MODEL: S630, S750, S6300, i950, i850,
i550, i6100, i6500

No.: PRNT-1216
(Q-12E-0063)
Date: 30.05.03

LOCATION: PART CHANGE NOTICE

SUBJECT: NEW DESIGNATION OF PAPER FEED MOTOR

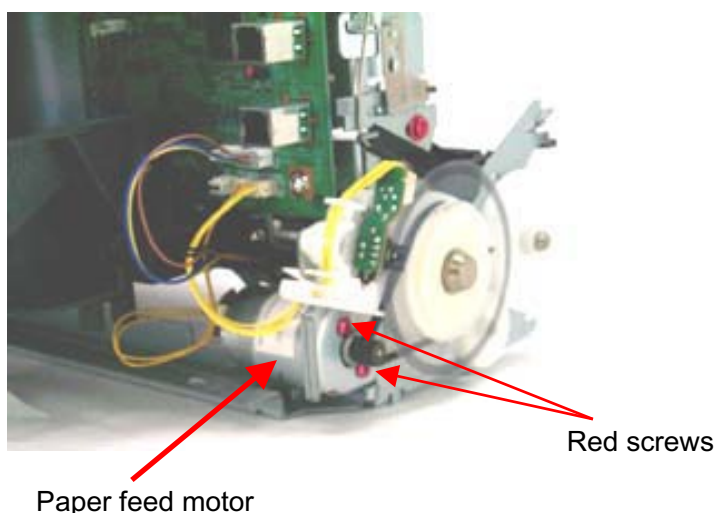
To improve serviceability, the paper feed motor (secured with 2 red screws) has been designated as a service part.

Removal of the paper feed motor in servicing was not allowed, as belt tension adjustment using the tool was required after re-attachment. However, as it has been confirmed that the paper feed motor can be replaced without using the tool, the part has been designated as a service part.

The paper feed motor should be removed only when necessary. When attaching it, be careful of the following points:

- (1) In attaching the paper feed motor, position the motor so that the belt is pulled tight, and fasten the screws.
- (2) After paper feed motor replacement, be sure to perform the service test print, and confirm that no strange noise or improper printing (such as due to dislocation of the belt, or out-of-phase of the motor, etc.) occurs.
